UT to Town Creek Restoration Project – Option A Final Monitoring Report/Closeout Report

DMS Project ID Number – 94648; NC DEQ Contract No. 003277

Submission Date: January 2021

Subject: Response to DMS Comments for DRAFT Monitoring Year 5 Report
UT to Town Creek Restoration Project – Option A
Yadkin River Basin – CU# 03040105 – Stanly County, NC
NCDMS Project ID No. 94648; NCDEQ Contract No. 003277

Figure 3 Continued. Cross-sections with Annual Overlays
UT to Town Creek Restoration Project - Option A: Project No. 94648

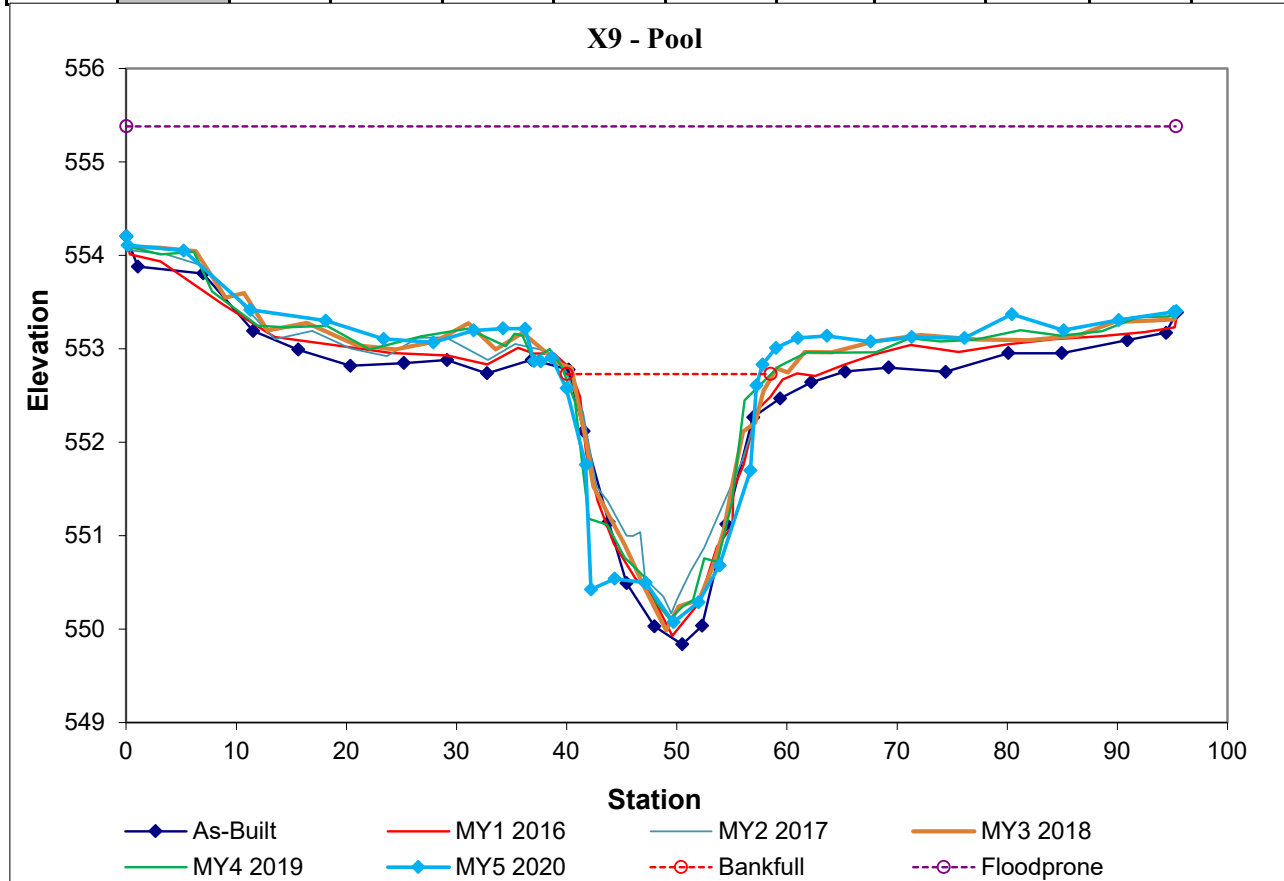
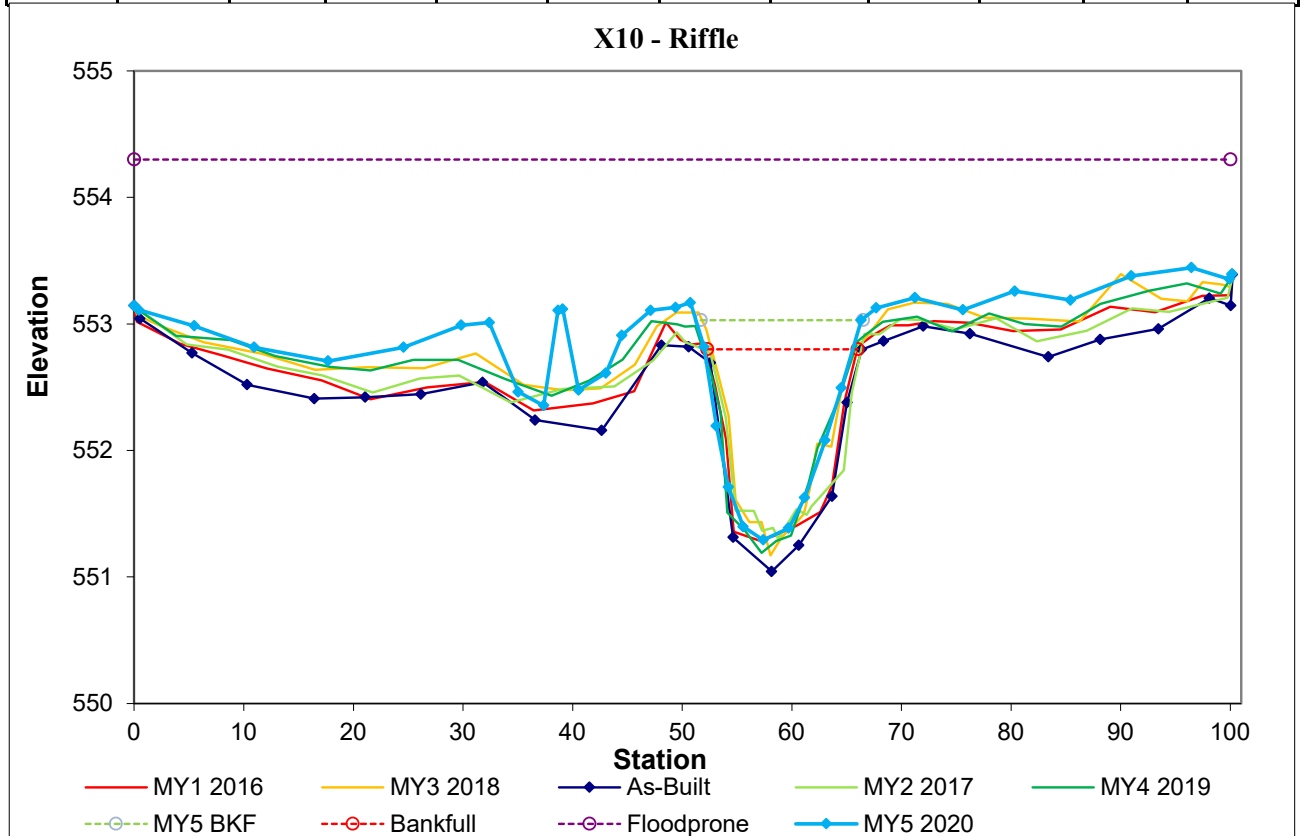
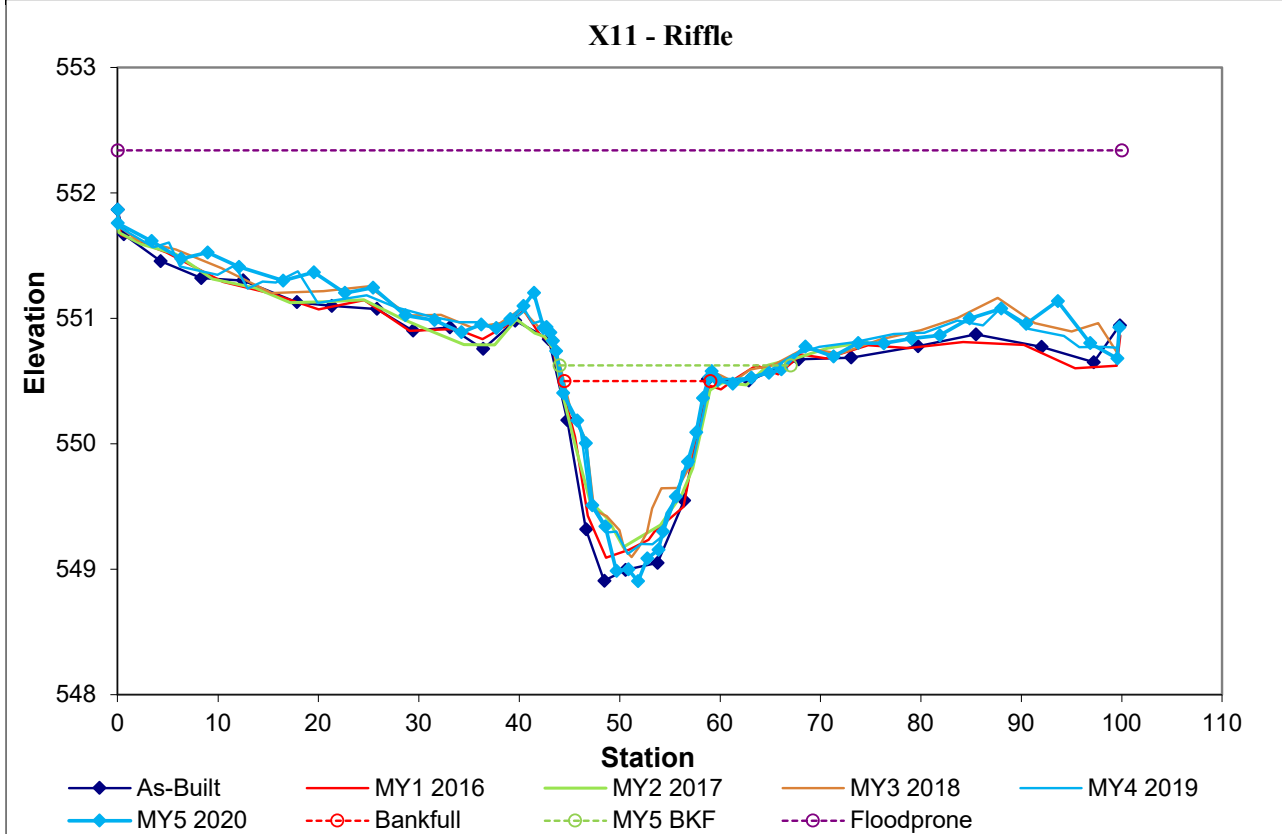
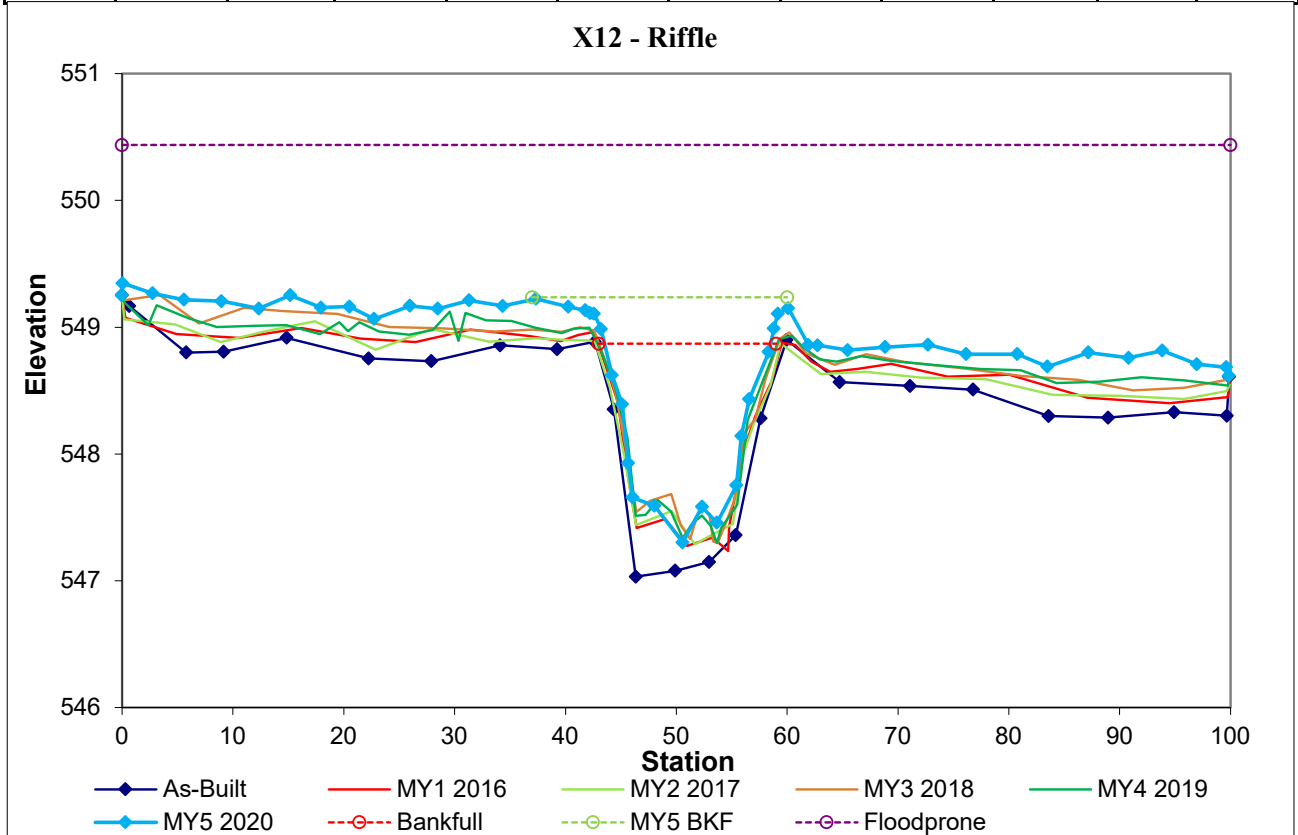
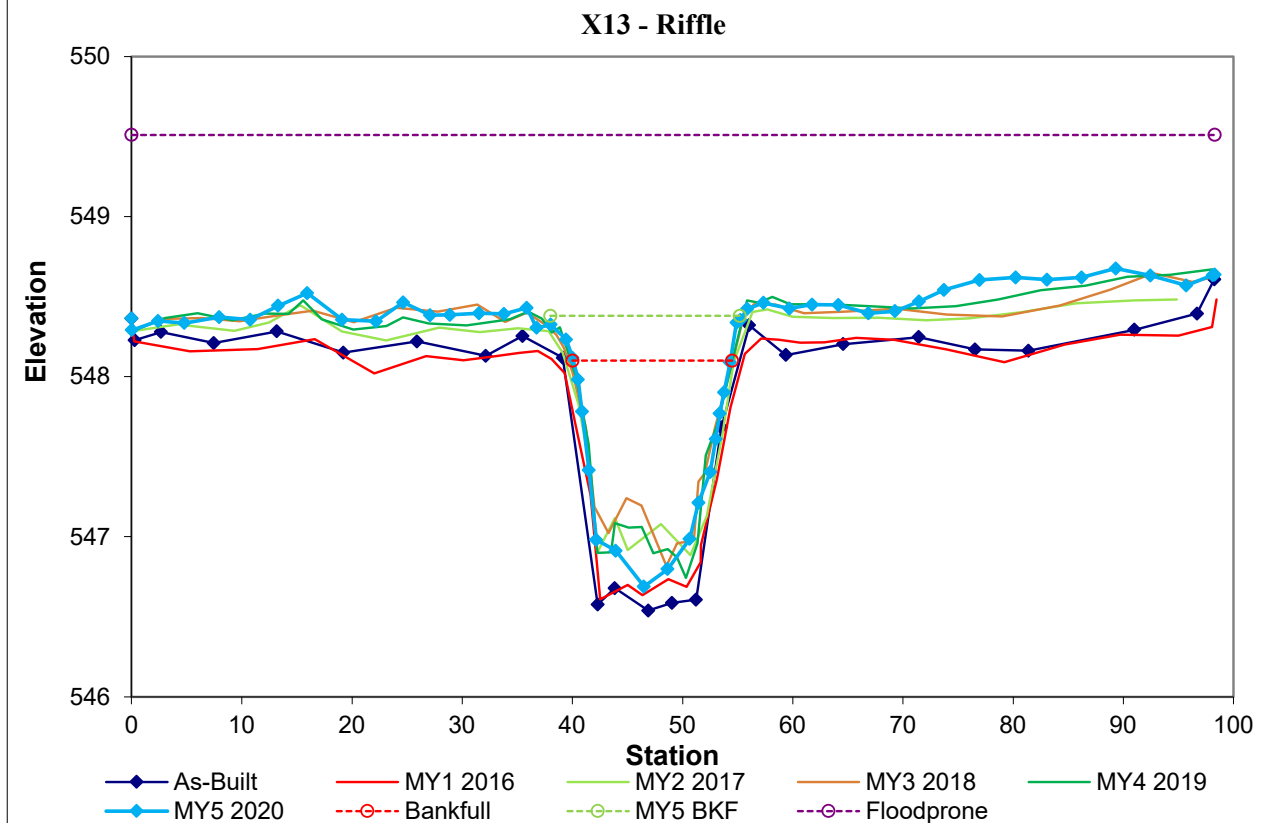
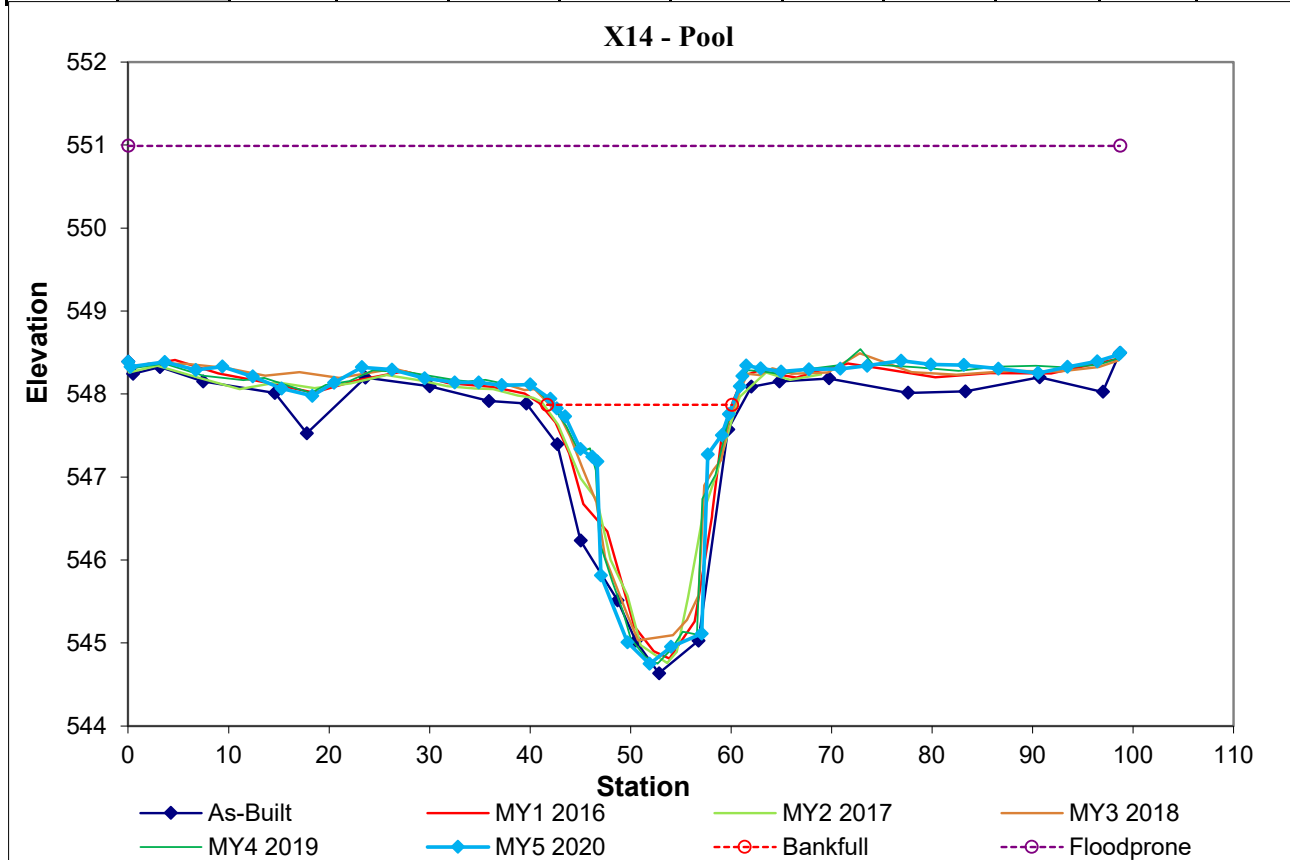
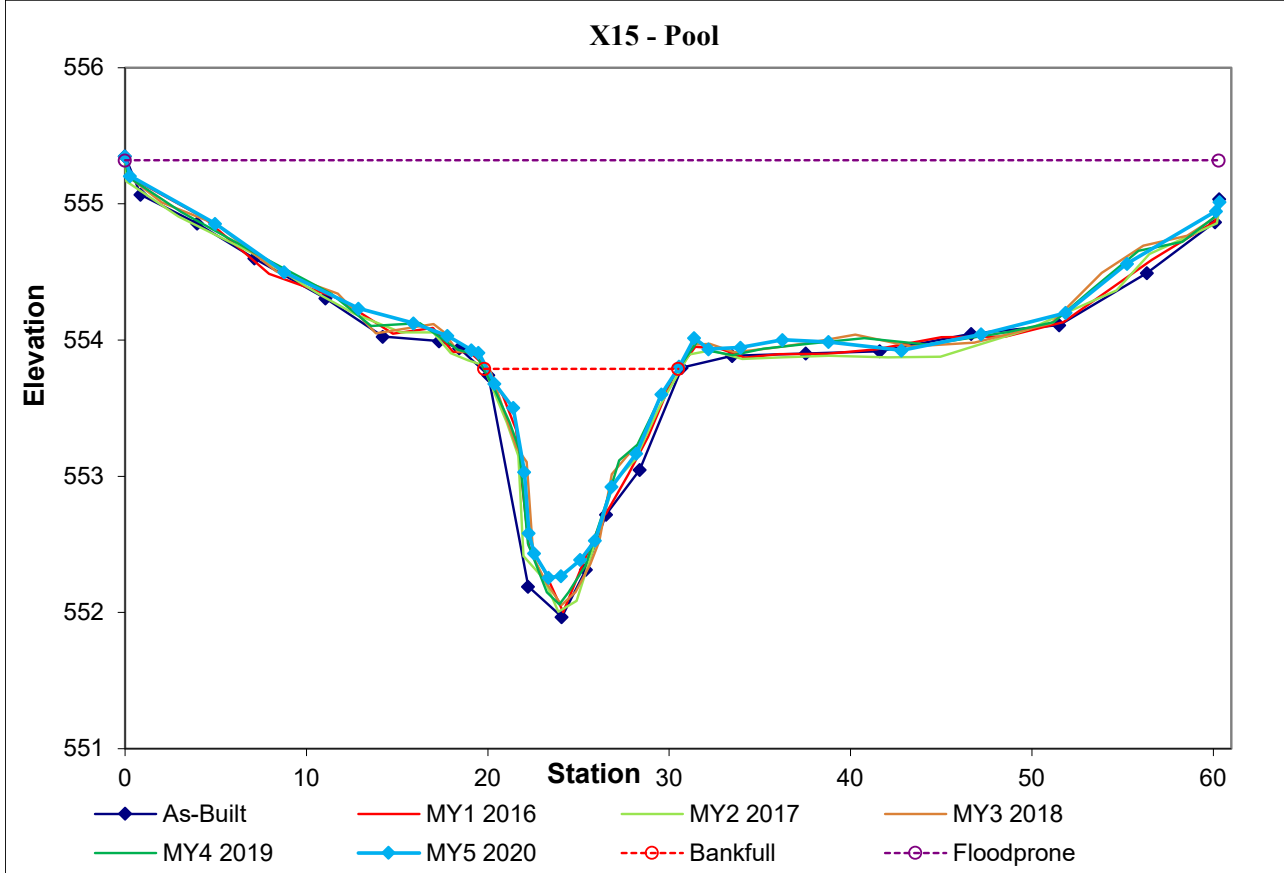
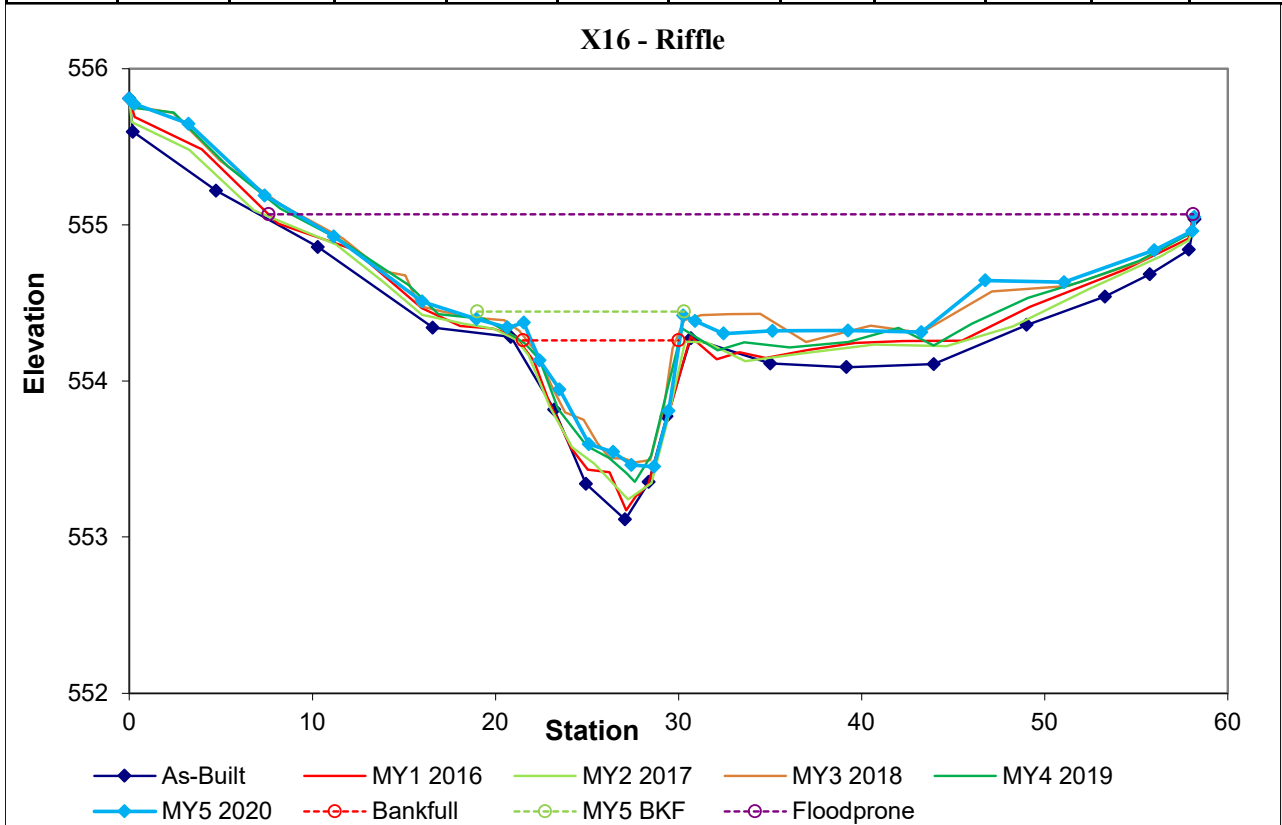
- *Please be sure that all cross section calculations are using MY5 data, and verify that the data being used in the BHR calculations are accurate. For example, it appears that XS 1 is still using MY4 data based on cell N29, while the XS 13 LTOB is listed as 565.3, but it is 565.057. The BHR calculations should be using the current monitoring year's low top of bank depth in the numerator, and in the denominator the depth at the elevation that achieves the MY0 cross sectional area in the MY5 channel should be used.*

Response: Revisions have been made to figure 3 and table 11a and 11b per DMS request.
